Status: Y ☒ N ☐ U ☐**Seismic Walkdown Checklist (SWC)**Equipment ID No. 1R43-C001A Equip. Class<sup>1</sup> 12Equipment Description DG 1A AIR COMPRESSOR 1A1Location: Bldg. DIESEL Floor El. 130 Room, Area DIESEL GENERATOR ROOM 1A

Status: Y ☒ N ☐ U ☐**Seismic Walkdown Checklist (SWC)**Equipment ID No. 1R43-C001A Equip. Class<sup>1</sup> 12Equipment Description DG 1A AIR COMPRESSOR 1A1**Interaction Effects**

5: Missing Screw in Fan Belt Housing Enclosure (1R43-C001A)

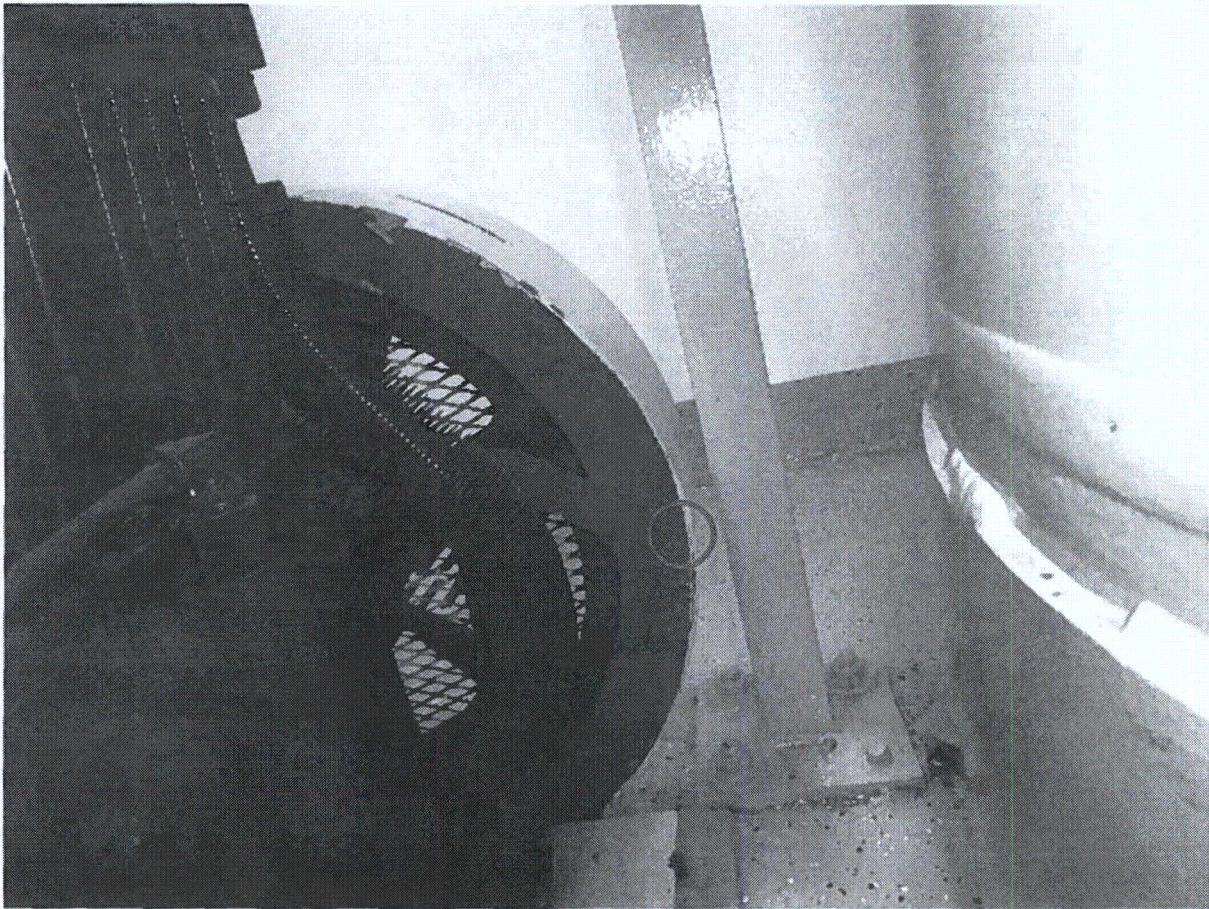
11. Have you looked for and found no other seismic conditions that could adversely affect the safety functions of the equipment? Y ☒ N ☐ U ☐  
*There is a missing screw on the fan belt housing cover plate for 1R43-C001A (see photograph 5). There are 7 other screws which are determined to be adequate to secure the cover plate. It is judged to be seismically adequate. CR 524556 has been written to install the missing screw.*

3: Fan Belt Enclosure Damage (1R43-C010B)

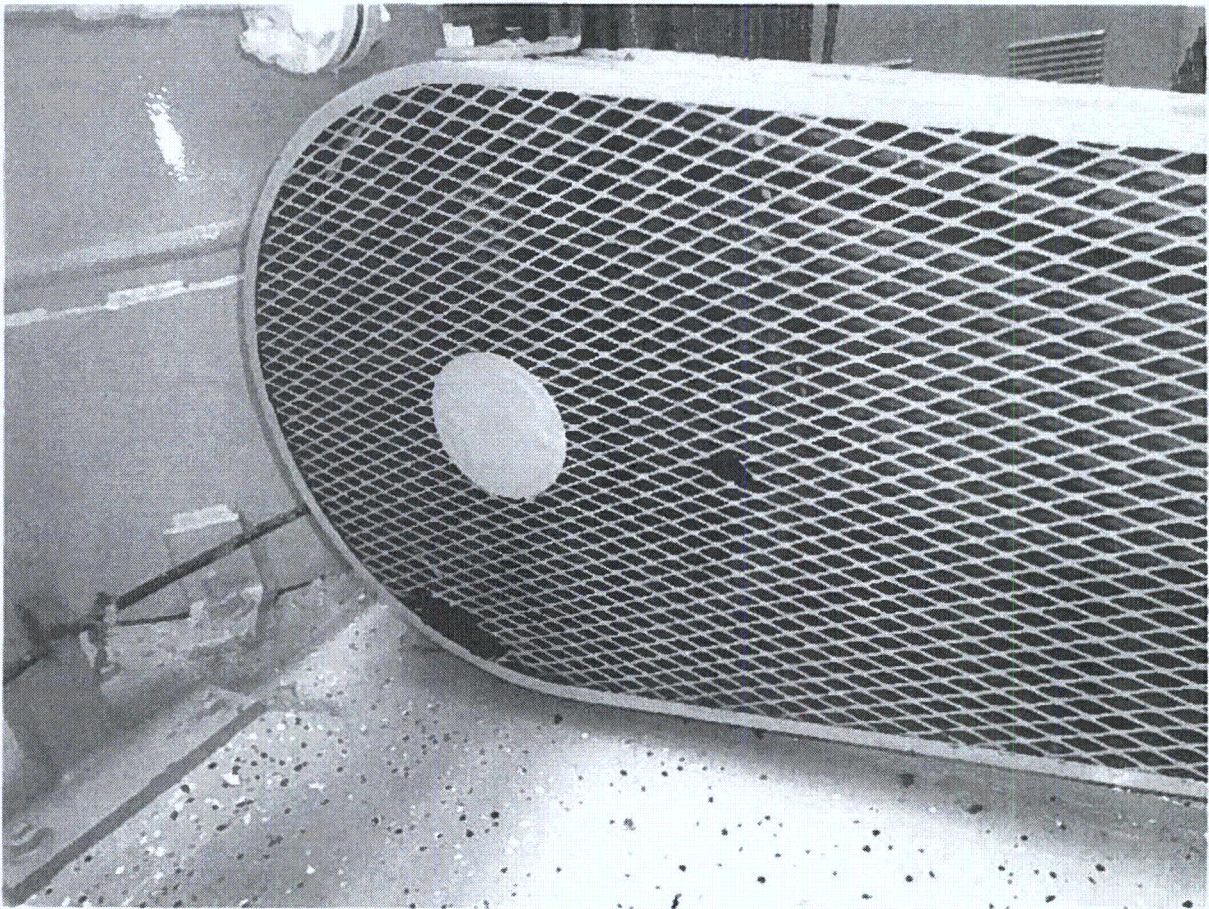
Status: Y ☒ N ☐ U ☐**Seismic Walkdown Checklist (SWC)**Equipment ID No. 1R43-C010B Equip. Class<sup>1</sup> 12Equipment Description DG 1B AIR COMPRESSOR 1B2**Interaction Effects**7. Are soft targets free from impact by nearby equipment or structures? Y ☒ N ☐ U ☐ N/A ☐8. Are overhead equipment, distribution systems, ceiling tiles and lighting, and masonry block walls not likely to collapse onto the equipment? Y ☒ N ☐ U ☐ N/A ☐9. Do attached lines have adequate flexibility to avoid damage? Y ☒ N ☐ U ☐ N/A ☐10. Based on the above seismic interaction evaluations, is equipment free of potentially adverse seismic interaction effects? Y ☒ N ☐ U ☐**Other Adverse Conditions**11. Have you looked for and found no other seismic conditions that could adversely affect the safety functions of the equipment? Y ☒ N ☐ U ☐**Comments** (Additional pages may be added as necessary)*See 1R43-S001B for AWC information.**Fan belt housing enclosure exhibited holes in the grid cover (see picture 3). CR 516335 has been written to resolve this issue.*Evaluated by: Juan VizcayaDate: 09/12/2012Patrick Kelly09/12/2012

3: Fan Belt Enclosure Missing Screws (1R43-C010C)

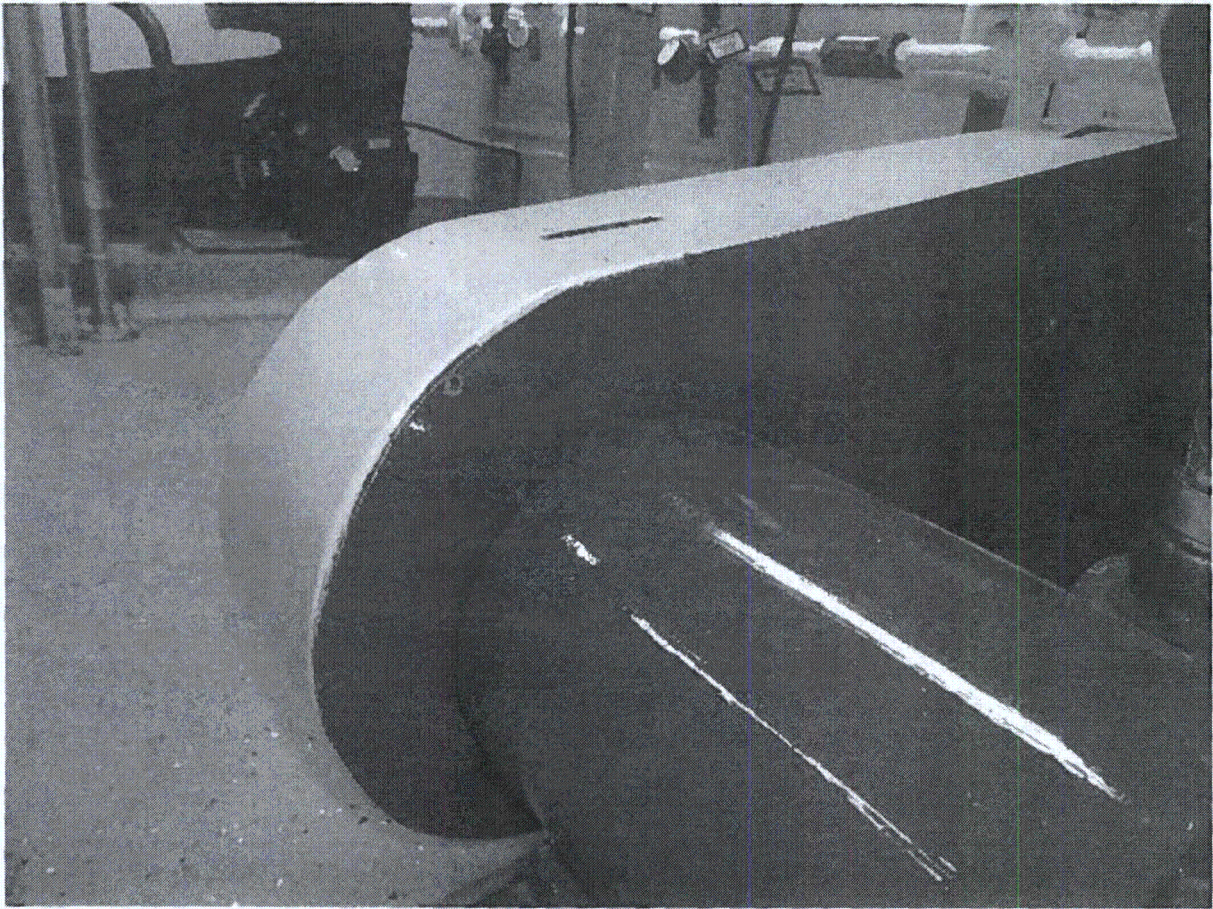
Status: Y ☒ N ☐ U ☐**Seismic Walkdown Checklist (SWC)**Equipment ID No. 1R43-C010C Equip. Class<sup>1</sup> 12Equipment Description DG 1C AIR COMPRESSOR 1C2**Interaction Effects**7. Are soft targets free from impact by nearby equipment or structures? Y ☒ N ☐ U ☐ N/A ☐8. Are overhead equipment, distribution systems, ceiling tiles and lighting, and masonry block walls not likely to collapse onto the equipment? Y ☒ N ☐ U ☐ N/A ☐9. Do attached lines have adequate flexibility to avoid damage? Y ☒ N ☐ U ☐ N/A ☐10. Based on the above seismic interaction evaluations, is equipment free of potentially adverse seismic interaction effects? Y ☒ N ☐ U ☐**Other Adverse Conditions**11. Have you looked for and found no other seismic conditions that could adversely affect the safety functions of the equipment? Y ☒ N ☐ U ☐**Comments** (Additional pages may be added as necessary)*See 1R43-S001C for AWC information.**The fan belt enclosure is missing two (2) screws for the fan belt housing enclosure (see photograph 3). CR 516348 has been written to resolve this issue.*Evaluated by: Juan VizcayaDate: 09/12/2012Patrick Kelly09/12/2012

Figure 3 – Light Fixture over Motor Generator (1C71-S001A)

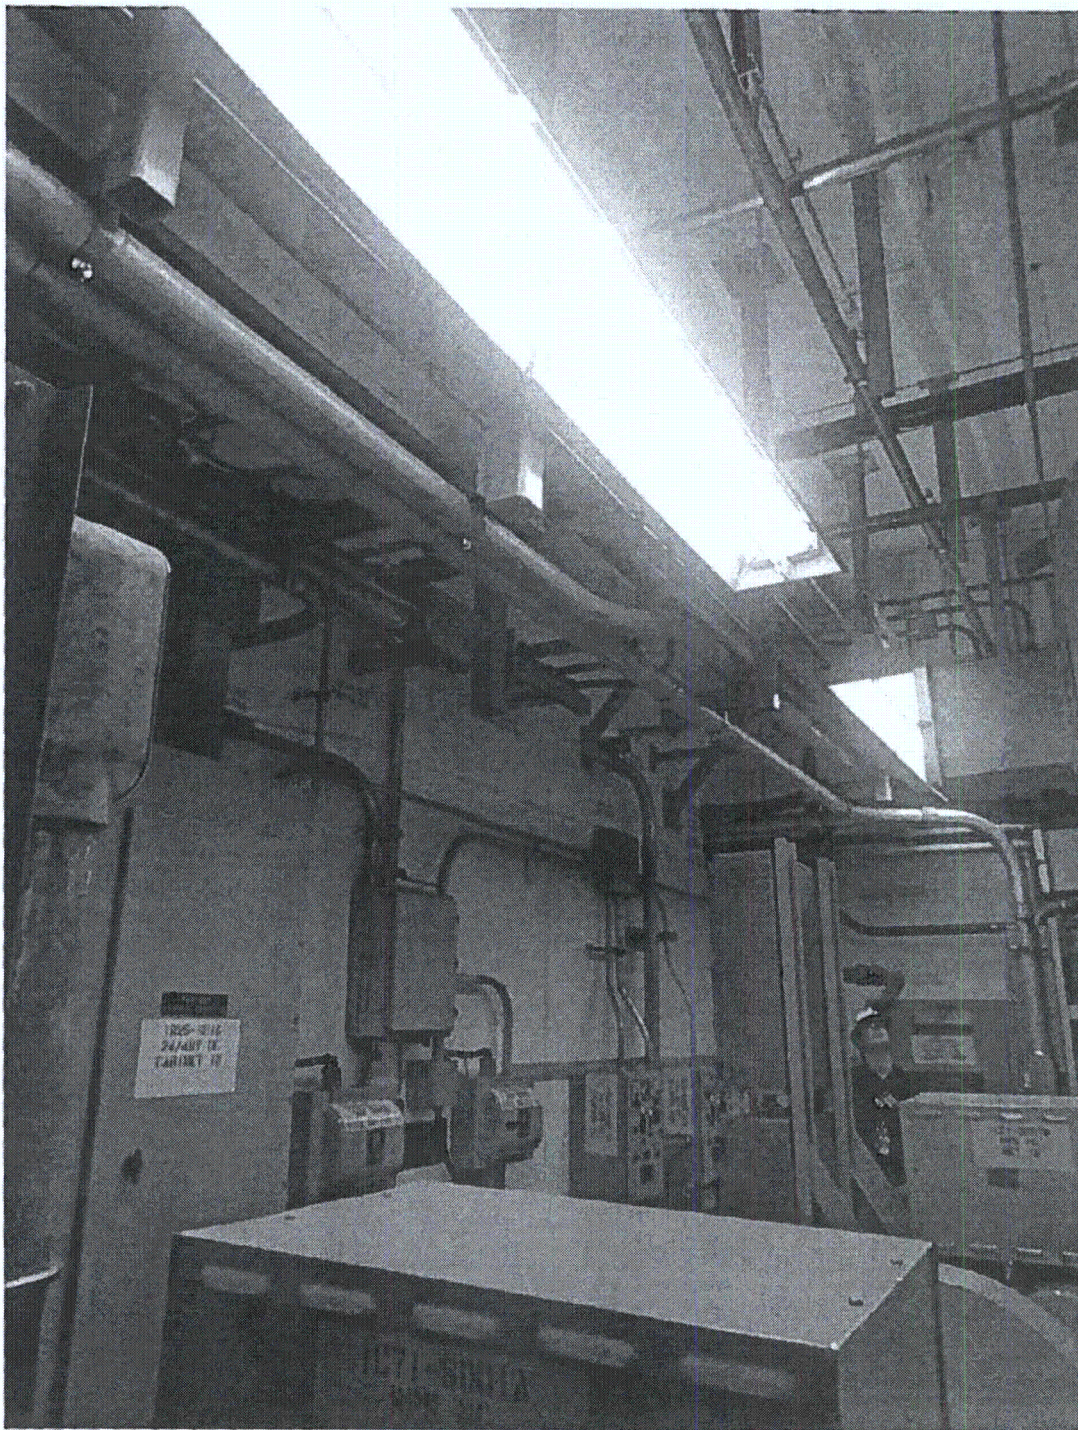
7. Are soft targets free from impact by nearby equipment or structures? Y ☒ N ☐ U ☐ N/A ☐
8. Are overhead equipment, distribution systems, ceiling tiles and lighting, and masonry block walls not likely to collapse onto the equipment? Y ☒ N ☐ U ☐ N/A ☐  
*The seismic capacity of the Concrete Block Walls C130-47E, C130-50B, C130-51A and C130-54A surrounding the Motor Generator were verified using Drawing H-40383 Rev. 2 and Hatch Unit 2 UFSAR Table 3.8-20.*  
*There is a fluorescent light fixture without a cover located over the component. The light is tied to the ceiling, so during a seismic event, only the bulb could fall. The motor generator is very rugged and is judged to have sufficient strength as to make a possible impact between the motor generator and the bulb will be insignificant. Therefore, it is judged to be seismically adequate.*

Figure 4 – Flex Conduit with Limited Slack (1C71-S001A)

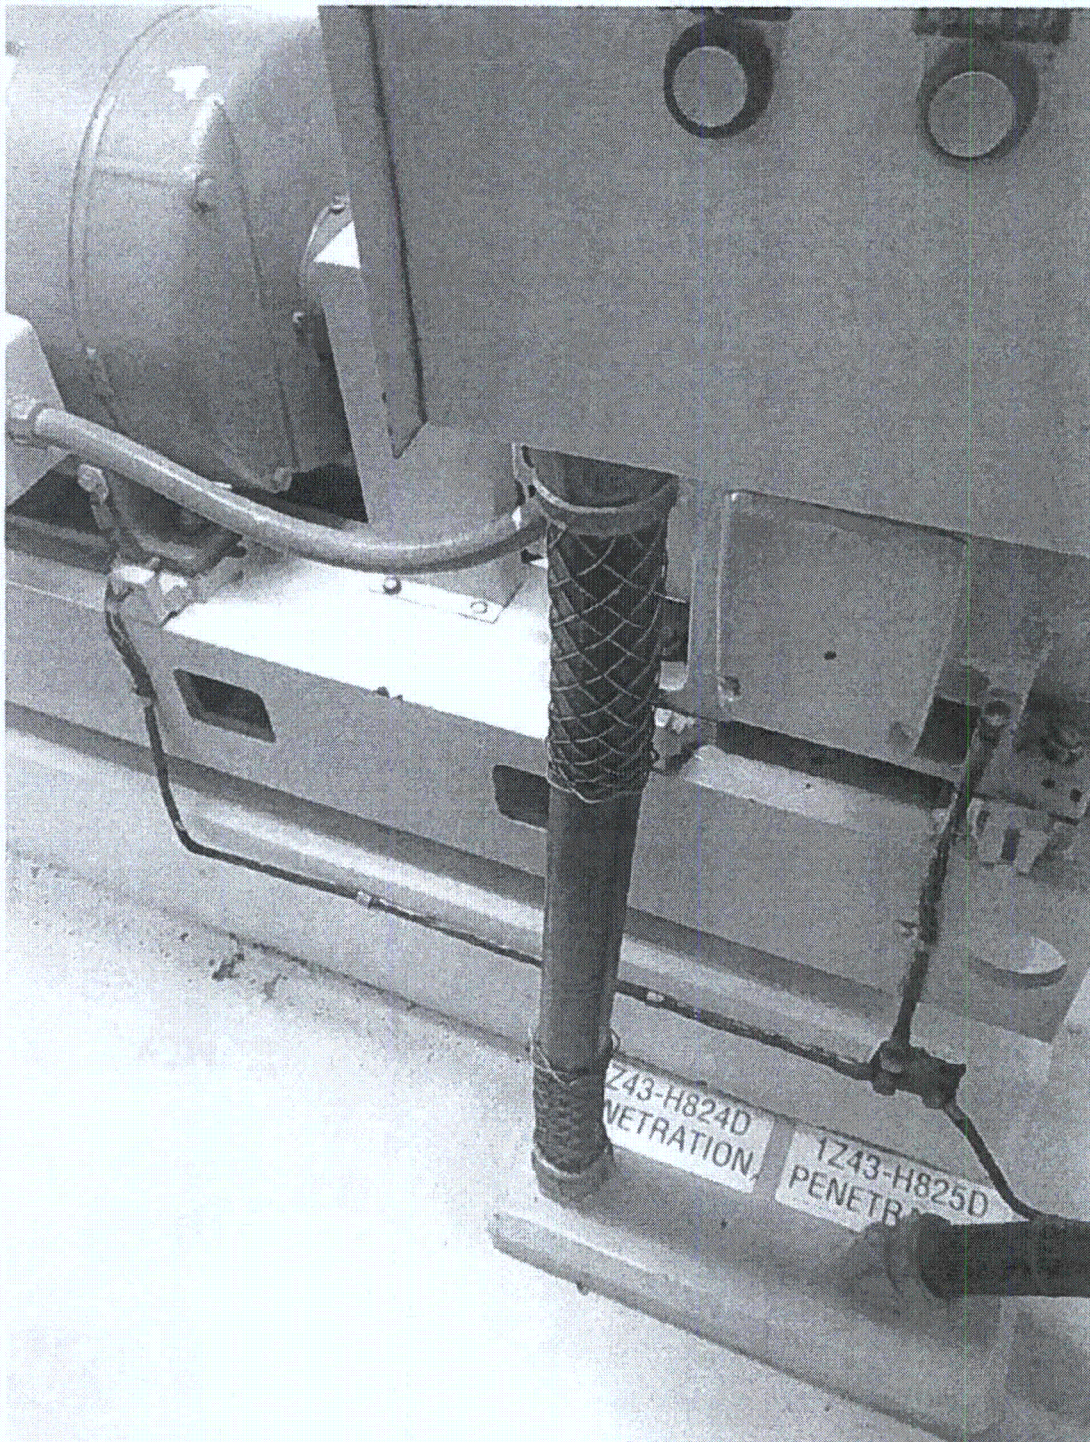
9. Do attached lines have adequate flexibility to avoid damage? Y ☒ N ☐ U ☐ N/A ☐  
*There is a section of flex conduit between the motor generator and a conduit support with limited slack. The motor generator is rigidly attached to the floor and has a low center of gravity, and the conduit support is rigidly attached to the floor. Therefore, there will not be much differential movement between the two ends of the flex conduit. The existing slack is judge to be sufficient for the very small differential movement, so there is no potentially adverse seismic condition.*

Figure 5 – Stability Holes Drilled in Motor Generator Casing (1C71-S001A)

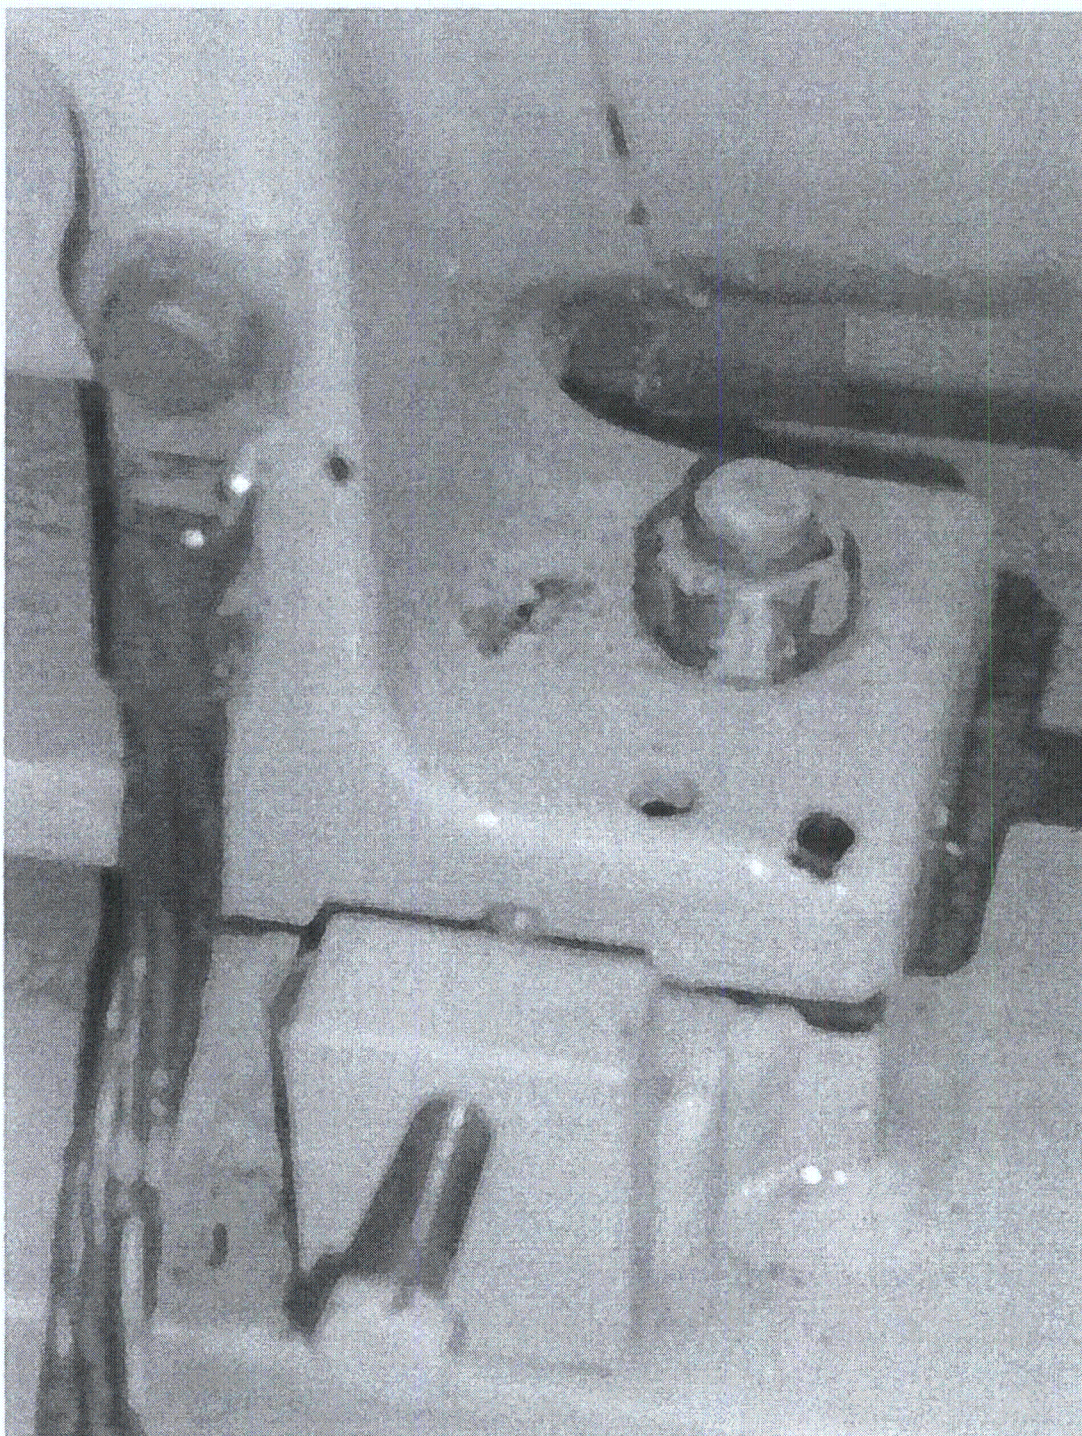
11. Have you looked for and found no other seismic conditions that could adversely affect the safety functions of the equipment? Y ☒ N ☐ U ☐  
*There are a number of drilled holes in the casing of the motor, particularly at anchorage locations. These holes appear to have been drilled to alter the balance of the motor and are clearly unrelated to component anchorage. Their presence does not indicate missing anchors or screws. Therefore, there is no potentially adverse seismic condition.*

Figure 3 – Fluorescent Light over Equipment (1C71-S001B)

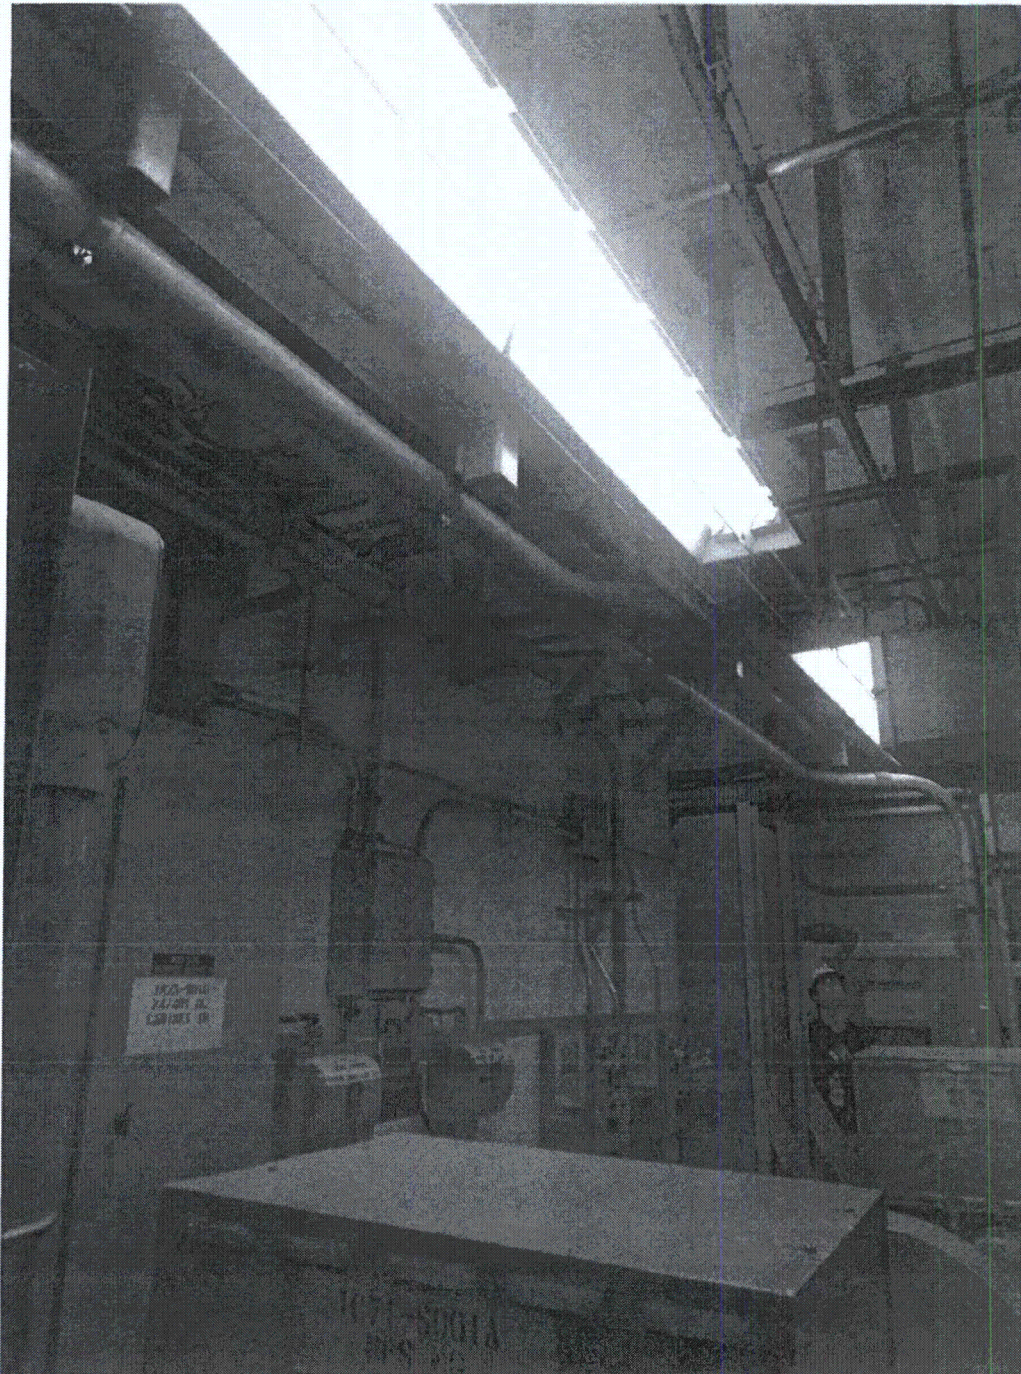
*There is a fluorescent light fixture without a cover located over the component. The light is tied to the ceiling, so during a seismic event, only the bulb could fall. The motor generator is very rugged and is judged to have sufficient strength as to make a possible impact between the motor generator and the bulb insignificant. Therefore, it is judged to be seismically adequate.*
